From: Lauren Griffin
Sent: Tuesday, 15 July 2025 09:53
To: Pj.Griffin@rps.tetrattech.com
Subject: RE: Case Number ABP-322329-25 Ballina Flood Relief Scheme

Our Ref: MGW0290L10012

Your Ref: ABP-322329-25

RPS (a Tetrattech Company) as an agent for the above noted planning application, submit the following comments on behalf of Mayo County Council in response to the invitation issued by An Coimisiún Pleanála (ACP) in their letter dated 17 June 2025 to make a submission on the observations received in relation to the Strategic Infrastructure Development Application (ABP-322329-25) for the Ballina Flood Relief Scheme (FRS). The letter requests that a response be received no later than on the 14 July 2025. The client and project team have considered the matters raised in the observations received from statutory consultees and third parties, namely:

Figure 1: Areas of sea lamprey spawning and nursery in Ridgepool (defined in May 2025) with proposed temporary instream works areas indicated

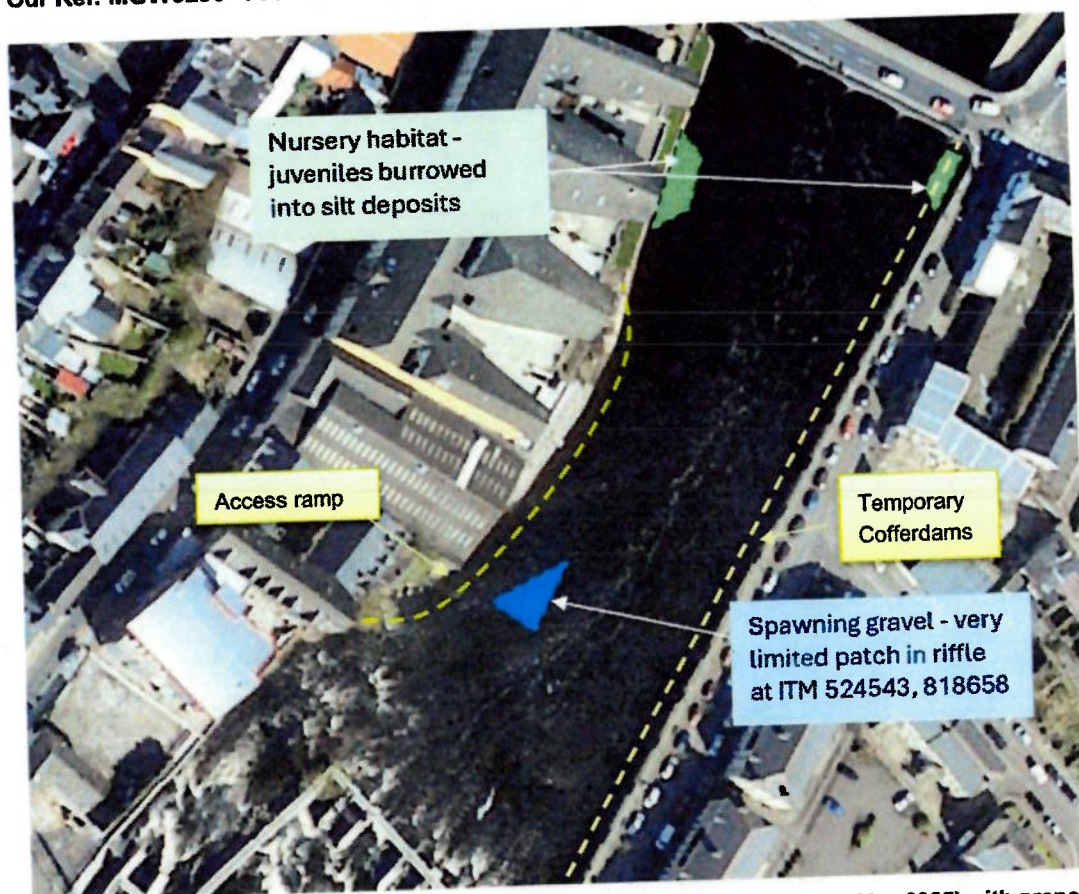
1. Note the "near threatened" and protected status of sea lamprey and request ACP to consider closely the instream works proposed.
2. Recommend the project be assessed against Article 4 of the Water Framework Directive to determine whether the project may cause a deterioration of the status of a surface or groundwater body or jeopardise the attainment of good surface or groundwater status or of good ecological potential and good surface or ground water chemical status.

juvenile lampreys (ammocoetes) captured at the areas marked in Figure 1, below. The additional site visit in May 2025 clearly identified the only area of suitable substrate and habitat where lamprey could be spawning in Ridge Pool (Figure 2). The reference point of the gravel riffle is: ITM 524543, 818658. A 'probable' sea lamprey redd was observed in this area (23 May 2025), identified by a patch of large gravels mounded up on the downstream side of a 1.5m oval depression. No lampreys were observed over the area, but given water temperature was >18 degrees at that time, spawning had likely occurred.

The May 2025 survey therefore reconfirmed and provided an additional layer of certainty and definition over what had already been found in September 2023 (reported in Appendix 9.6 of the EIAR) with the benefit of occurring within sea lamprey spawning season. The area of potential sea lamprey spawning habitat in the Ridge Pool during spawning season is confined to that one gravel riffle as shown in Figures 1, 2 and 3, below. There is no spawning habitat on the RHS (Ridgepool Road).

The patch of nursery habitat on the LHS in front of Ballina Manor is not impacted by the proposed instream works and will be cordoned off on the landward side and marked as an "exclusion zone" during works in the Ridge Pool as clearly set out in Section 9.5.1.3 (Mitigation – Ridge Pool, River Moy) of Chapter 9 of the EIAR.
